Preliminary Drainage Report  
for  
**Rolling Hills Ranch North**  
at  
**Meridian Ranch**

September 2023

# Rolling Hills Ranch North PUD Preliminary Drainage Report

TECH CONTRACTORS 11886 STAPLETON DRIVE FALCON, CO 80831 TELEPHONE: 719.495.7444 FAX: 719.495.3349		Revisions	
MERIDIAN RANCH		No.	Date
RATIONAL DRAINAGE MAP PRELIMINARY DRAINAGE REPORT ROLLING HILLS RANCH NORTH AT MERIDIAN RANCH		Date	
Drawn by	TAK	Checked by	-
Scale	1" = 100'	Date	SEPT 2023
5	of	6

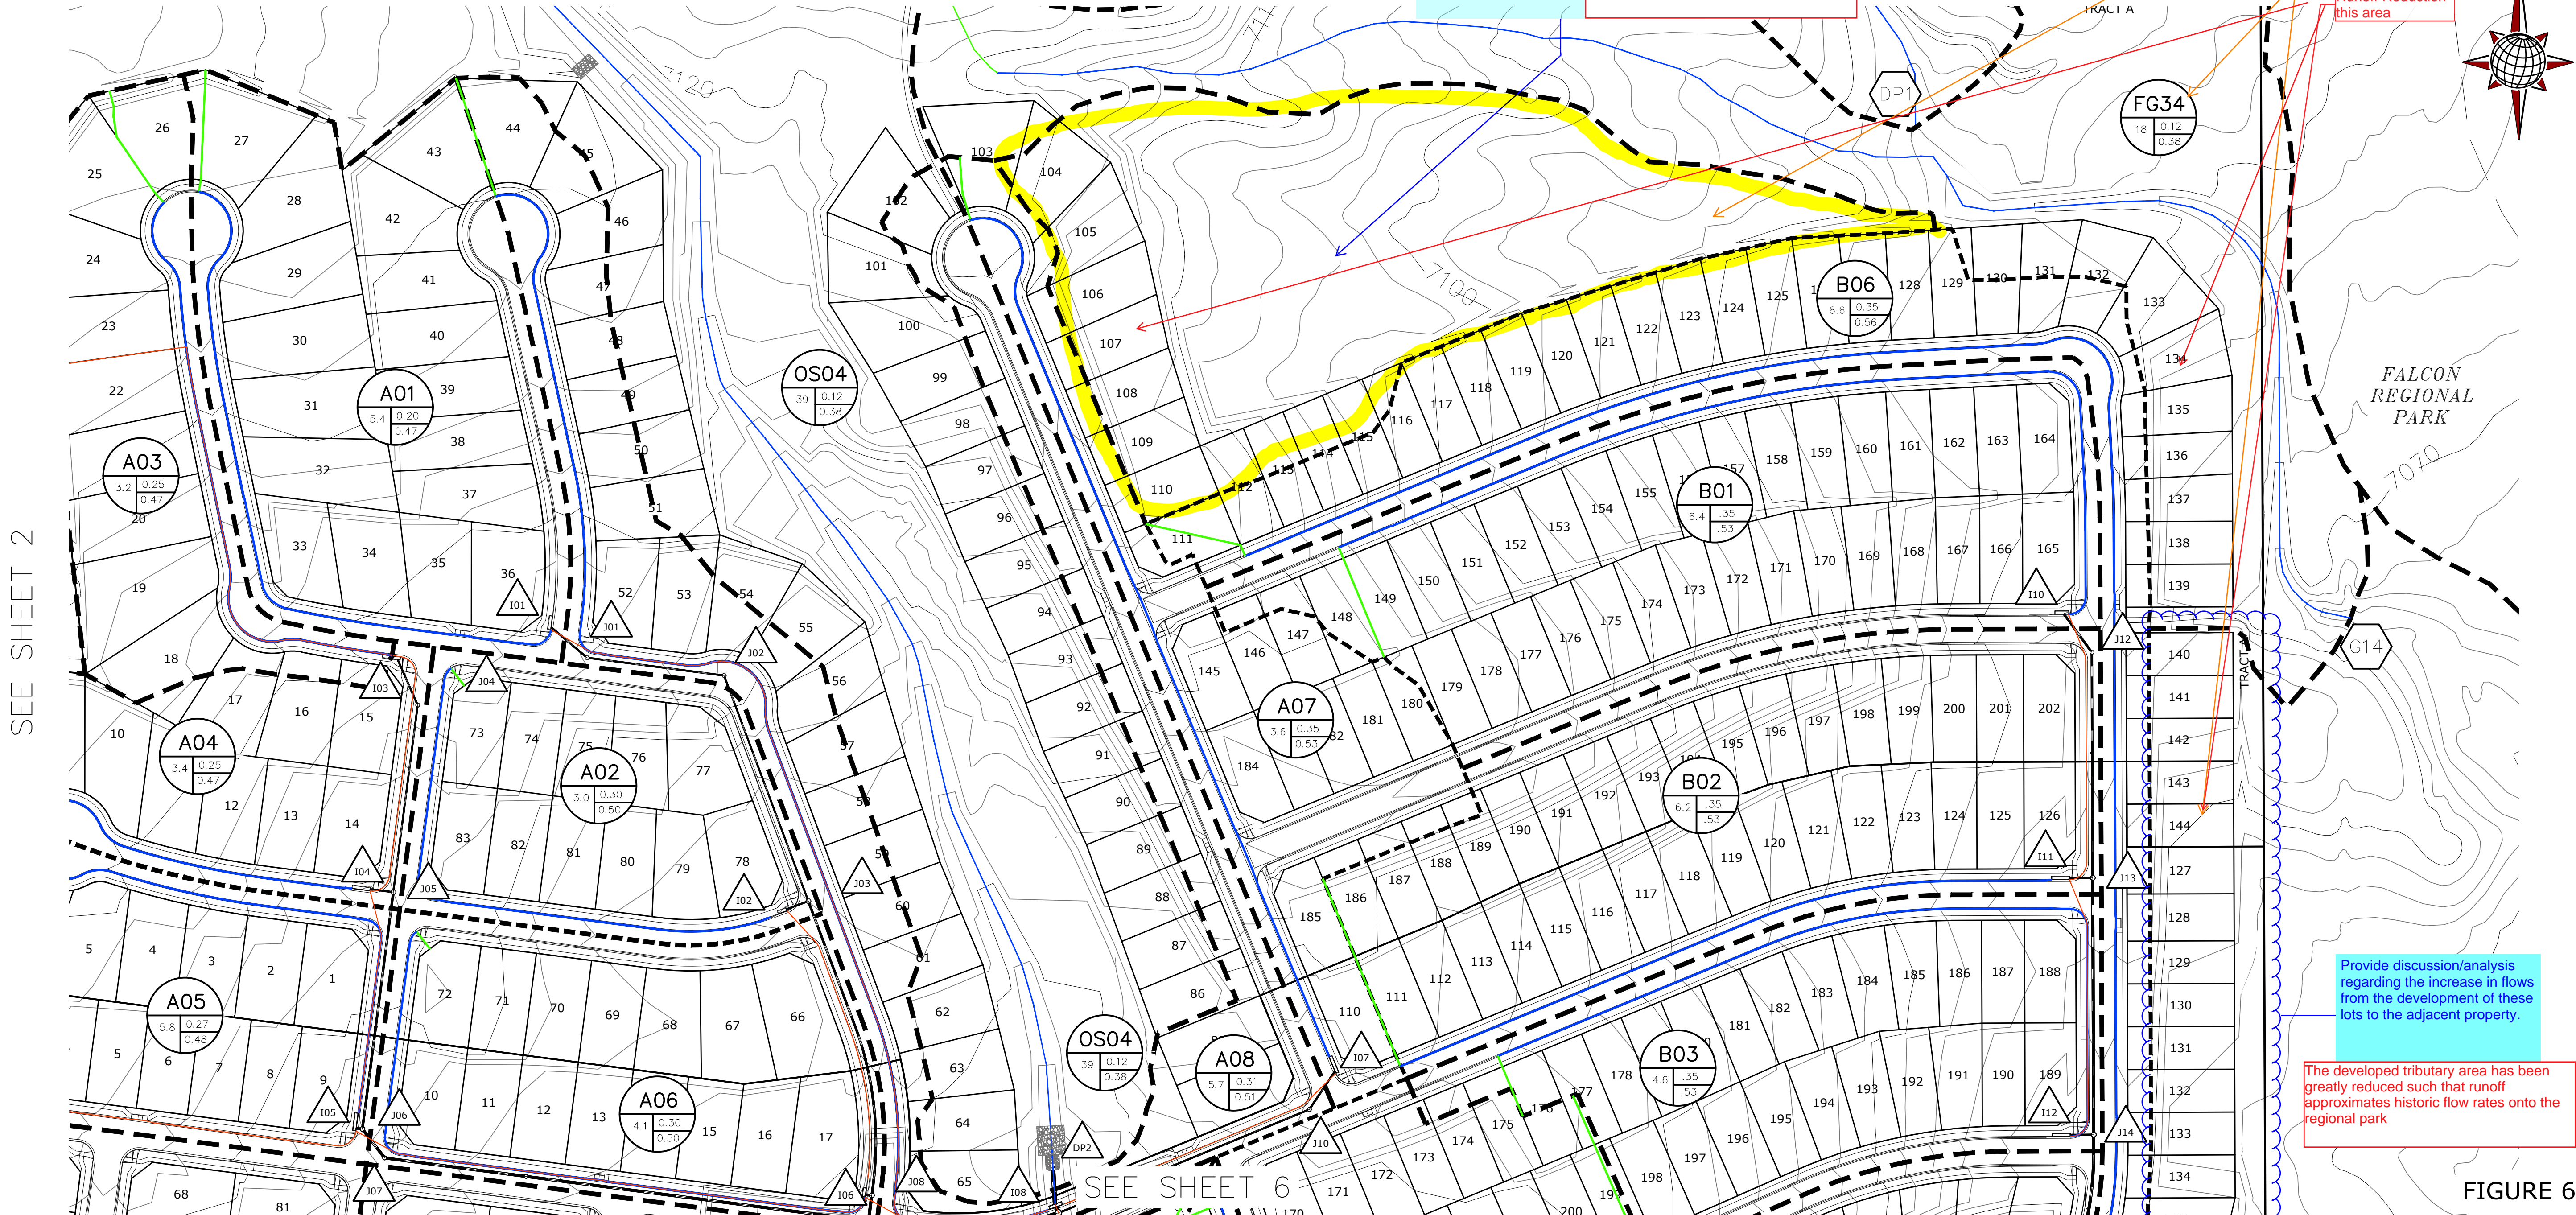
Provide discussion/analysis of this basin as well as basin FG34. Identify whether the channel within basin FG34 was designed to account for the developed flows of the lots in this basin and FG34.

Discussion water quality for this basin.

Provide discussion/analysis regarding the increase in flows from the development of these lots to the adjacent property.

The developed tributary area has been greatly reduced such that runoff approximates historic flow rates onto the regional park.

The developed tributary area has been greatly reduced such that runoff approximates historic flow rates onto the regional park.

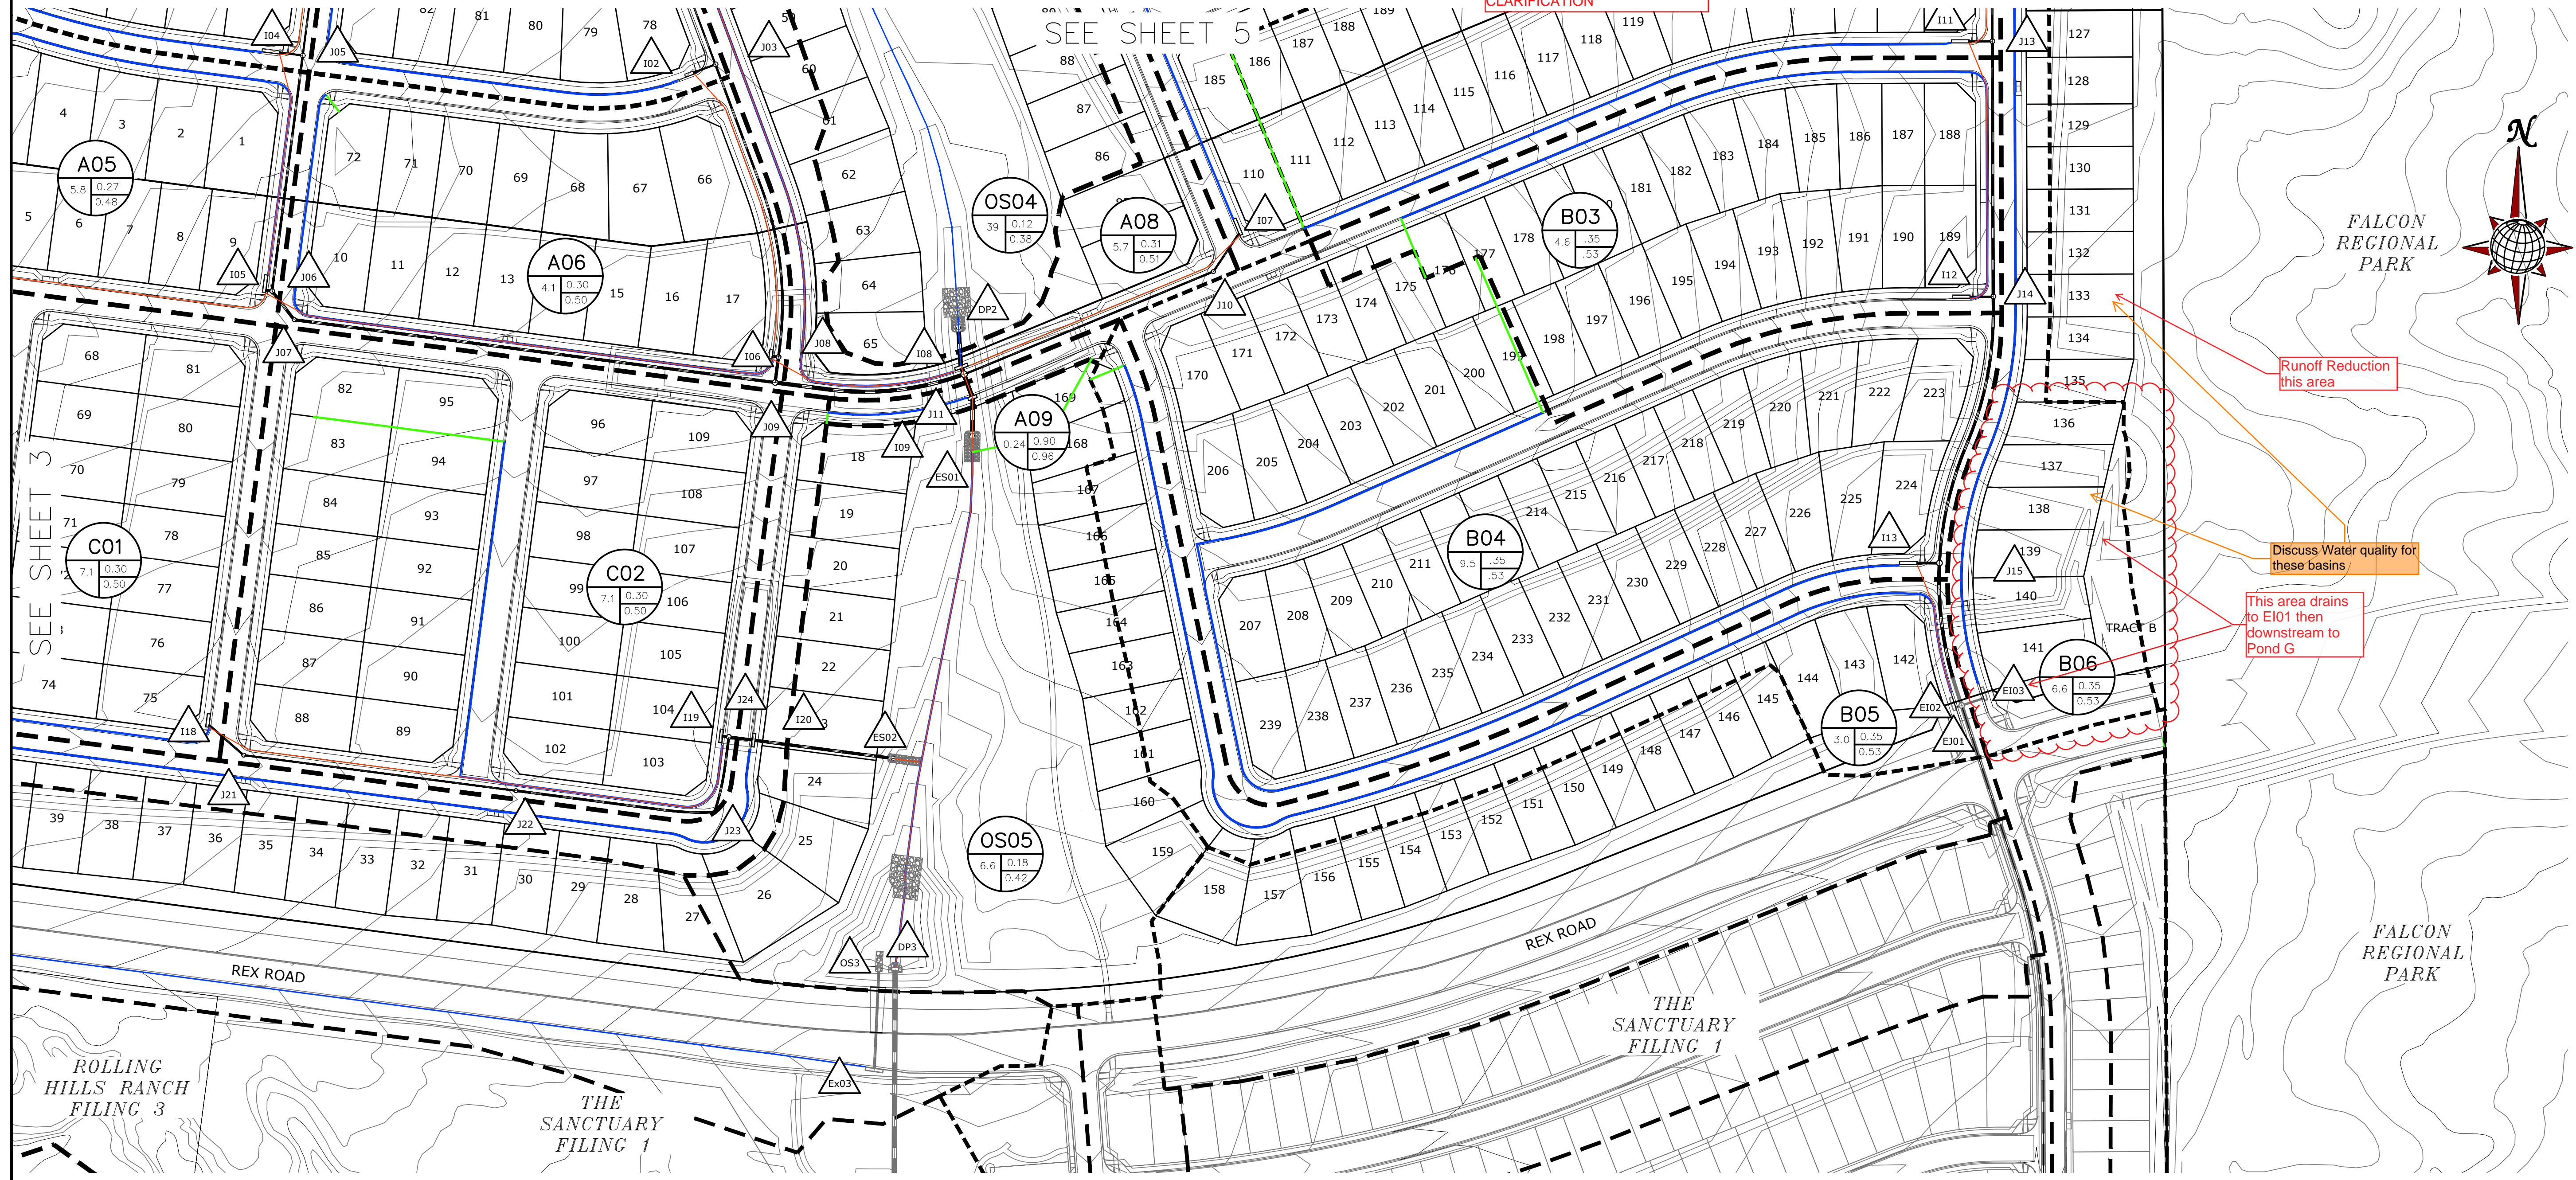
please provide flows for DP ES01 and ES02 in the summary table  
 ADDED DOWNSTREAM COLUMN TO TABLE FOR ADDITIONAL CLARIFICATION
